Illinois Department of Transportation

Memorandum

To: Paul A. Loete, Dist. 3
From: D. Carl Puzey
Subject: Hydraulic Report
Date: June 14, 2013

Illinois 178 over the Illinois River at Utica

PIER SKETCH
(Piers 1 & 2)

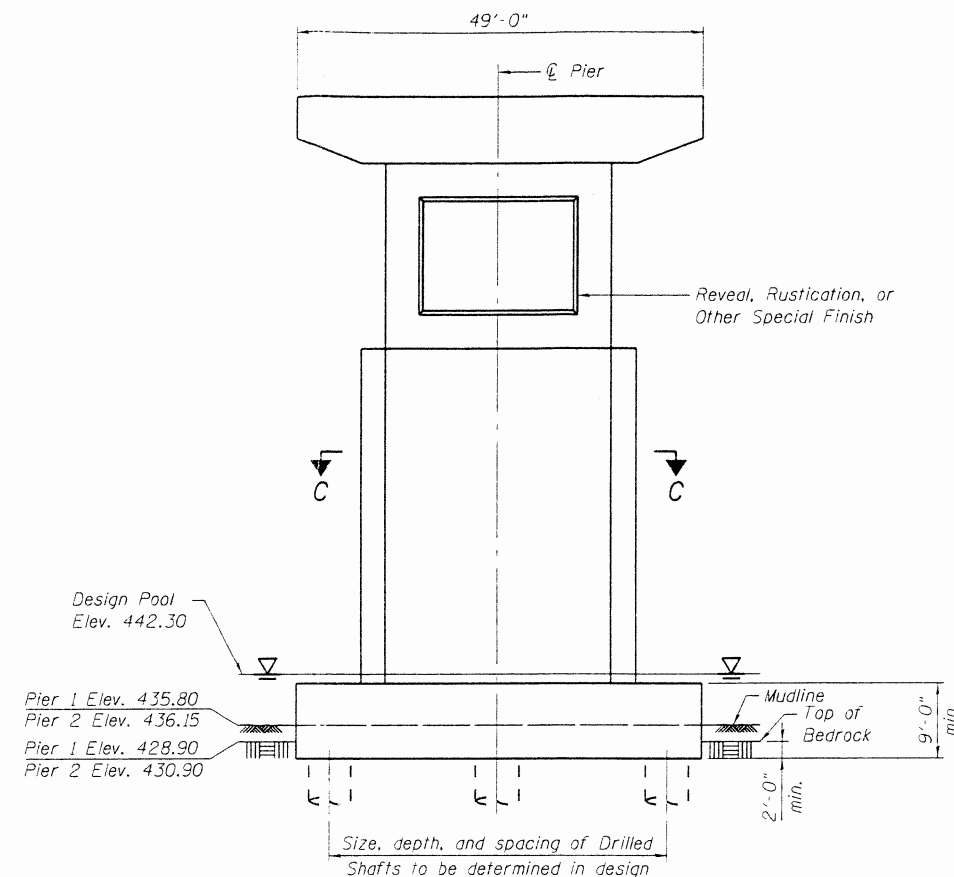
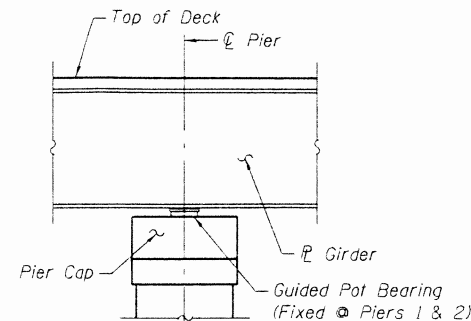
The proposed scour analysis produced deep scour depths. It is understood that non-weathered limestone or dolomite occurs above the calculated scour elevations. The geotechnical analysis will adjust the scour for that condition. However, the existing channel piers 3 and 4 and proposed piers 1 and 2 could undergo additional scour, due to the close proximity of the existing structure to the proposed, if a flood should occur before demolition of the existing bridge.

- The raw scour analysis indicated the potential for deep scour at the proposed bridge. The geotechnical review will determine if the actual soil/rock conditions can be used to reduce the raw scour depths. The raw scour depths for the proposed bridge piers are 31', 38', 41', and 44' for the 10, 50, 100, and 500 year floods respectively.
